**Final Determination on the
Appropriateness of the Model Year
2022-2025 Light-Duty Vehicle
Greenhouse Gas Emissions Standards
under the Midterm Evaluation**

Response to Comments

U.S. Environmental Protection Agency
Assessment and Standards Division

Figure 2-7 EPA TDS24 1.17L I3 Combined Cycle Fuel Consumption Distribution vs. Engine Torque

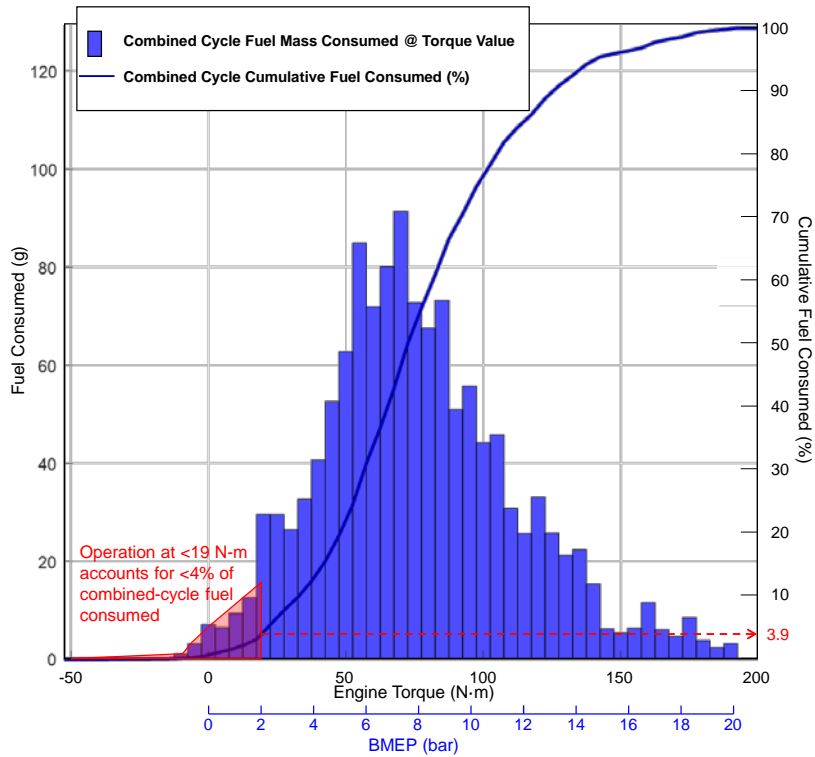
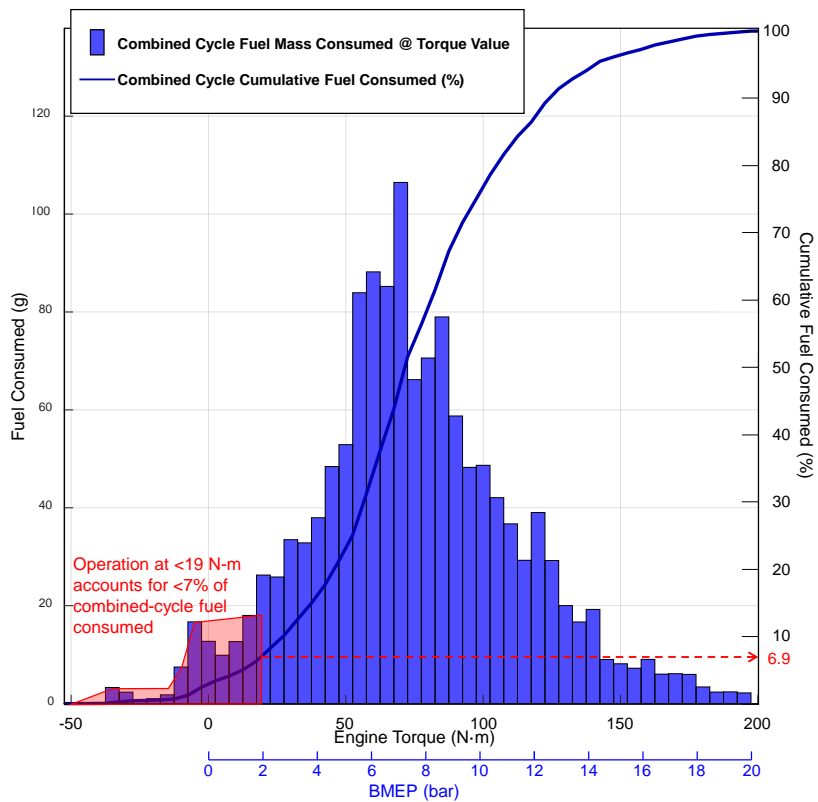
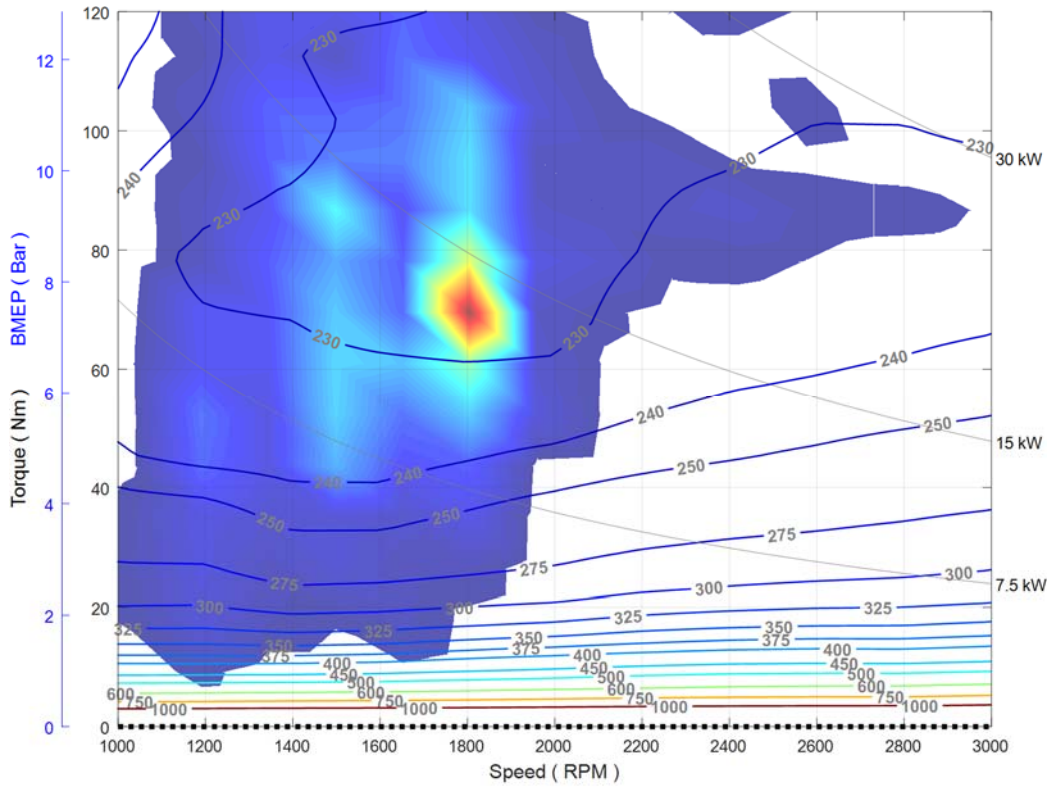
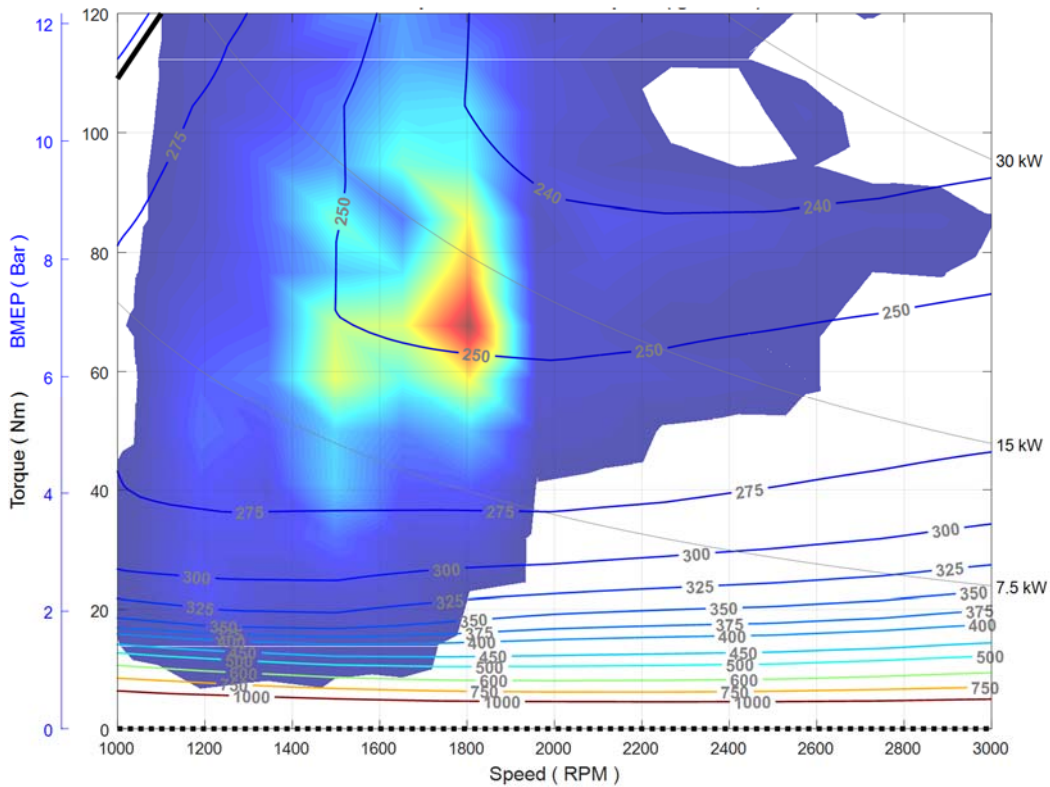
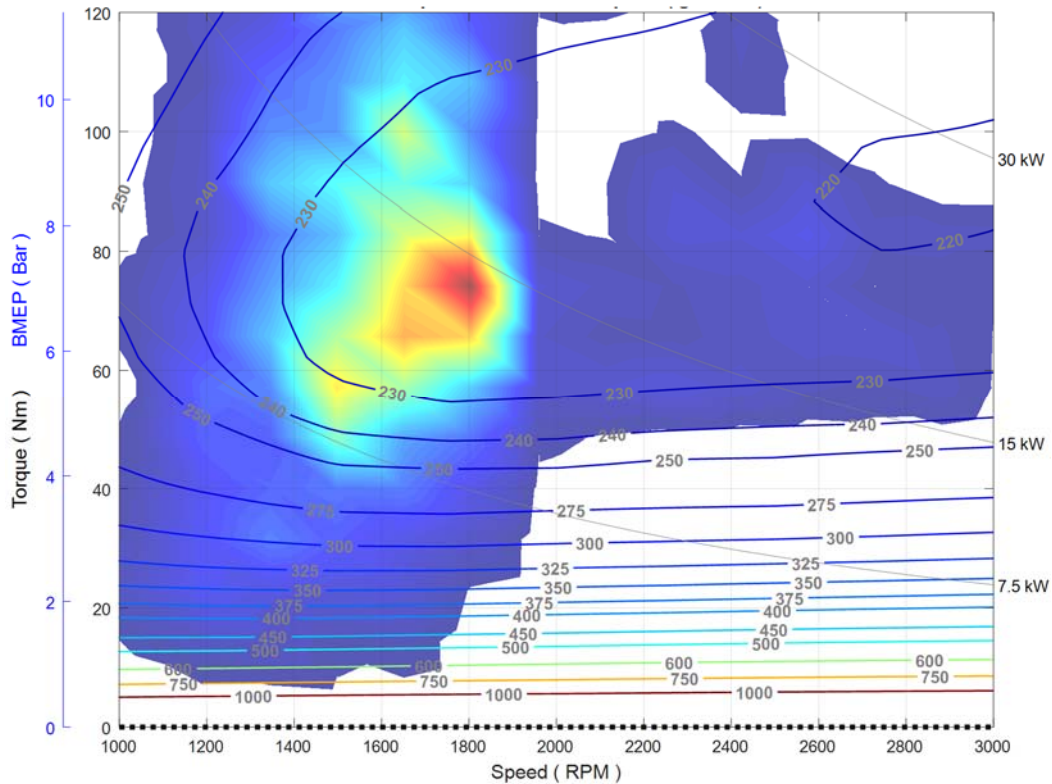
An initial analysis looked at fuel usage for a region of operation identified by the Alliance in its comments as important for compliance over the drive cycle. This region of operation within the Alliance's analysis showed 10-20% fuel differences and represented operation of TDS24 at below 2-bar BMEP or approximately 19 N-m of torque (see the Alliance comments on Proposed Determination, Figure 3). Figure 2-7 and Figure 2-8 show the contribution of mass of fuel consumed at different torque points (i.e., torque at all speeds) encountered over the combined FTP and HwFET cycles as well as cumulative fuel usage over the combined cycles for 1.17L TDS24 and a Ford 2.7L Ecoboost scaled for equivalent performance (1.24L 3-cylinder). Operation over the regulatory cycles at less than 19 N-m of torque accounted for less than 4% of fuel used by TSD24 and less than 7% of fuel used by the Ford Ecoboost 2.7, and thus the sub-19 N-m region of operation with 10-20% fuel consumption differences would account for a difference of approximately 1% over the drive cycle.

The engines were all scaled to provide approximately equivalent torque between 1000 and 3500 rpm to TDS24 and equivalent vehicle performance for a low power-to-weight ratio, high road-load (LPW-HRL) vehicle configuration similar to a CUV. This vehicle configuration was chosen to be approximately comparable to the vehicle configuration summarized by the Alliance within Table 1 of their comments on the Proposed Determination. Table 2-4 appearing below summarizes the vehicle, engine and transmission combinations analyzed. The vehicle configurations with turbocharged/downsized engines were also compared to an exemplar vehicle with a 2.38 L naturally aspirated GDI engine and 6-speed automatic transmission to reflect an approximately MY2015 level of technology. The examples with turbocharged/downsized engines were configured with advanced 8-speed automatic transmissions, a 5% reduction in vehicle mass, and 10% reductions in rolling resistance and aerodynamic drag to reflect a moderate level of road load reduction for compliance with 2022-2025 LD GHG standards.

Uncertainty in fuel flow measurements increases at very light loads due to the resulting low fuel flow rates. Relatively small differences in differences in fuel flow measured at light-load (i.e., low-flow) conditions appear large on a percentage basis even if absolute differences are small and even if such operating conditions do not represent a significant contribution to cycle-integrated fuel consumption or CO₂ emissions. The relative importance of different speed/load conditions on fuel consumed over the drive cycles can be visualized using “heat maps” such as those shown in Figure 2-9, Figure 2-10, and Figure 2-11 for TDS24, and the scaled Ford Ecoboost 2.7L and Honda L15B7 engine configurations, respectively. Please note that the heat maps were plotted over the same 1000-3000 rpm and sub-120 N-m torque operational range shown within Figure 2 and Figure 3 of the Alliance comments to the Proposed Determination and do not reflect the full range of engine operation. The “heat maps” indicate that fuel consumption differences at higher load conditions than those identified by the Alliance (e.g., from approximately 40 N-m to approximately 110 N-m torque) would be significantly more important with respect to drive cycle fuel consumption and CO₂ emissions than operation at less than 19 N-m of torque for the specific examples shown here and within the Alliance comments to the Proposed Determination.

Figure 2-12 Percentage Differences in Fuel Consumption Between The 1.17L TDS24 and the MY2015 Ford Ecoboost 2.7L Engines (left) and between the MY2017 Honda L15B7 and the MY2015 Ford Ecoboost 2.7L Engines.

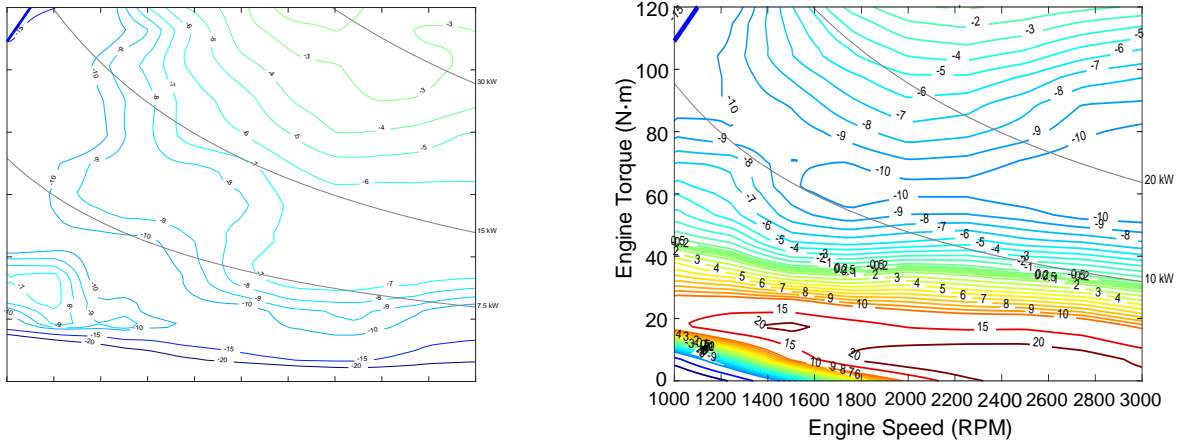
Figure 2-12 and Figure 2-13 are EPA’s recreation of Figure 2 and Figure 3, respectively, from the Alliance comments to the Proposed Determination showing fuel consumption differences between 1000 – 3000 rpm and below 120 N-m of torque. Figure 2-12 shows a comparisons of

When properly scaling the engines for equivalent torque, EPA’s analysis found somewhat larger differences at light loads between TDS24 and the scaled Ford Ecoboost 2.7L and significantly larger differences relative to the ANL 24-bar configurations. Comparing the scaled Honda L15B7 engine to the scaled Ford Ecoboost 2.7L and the ANL 24-bar configuration showed remarkably similar differences to those found with the comparison to TDS24 despite the Honda engine’s lack of some of the technologies used for TDS24 (e.g., cEGR, VVL and VNT).

Note: Technology used by TDS24 but not used in the MY2015 Ford Ecoboost 2.7L includes higher pressure, centrally-mounted piezo fuel injection; variable valve lift; VNT turbocharging; cooled low and high pressure external EGR; and higher cylinder pressure capability. Technology used by the MY2017 Honda L15B7 TDS24 but not used in the MY2015 Ford Ecoboost 2.7L includes higher pressure solenoid fuel injection, improved S/B ratio (~1.2) for reduced thermal losses and increased intake port tumble for improved combustion phasing. Both the Ford Ecoboost 2.7L and the Honda L15B7 have large ranges (≥ 50 °CAD) of both intake and exhaust cam phasing authority, but EPA benchmarking of both engines shows a larger range cam phasing, particularly at light load, for the Honda L15B7.
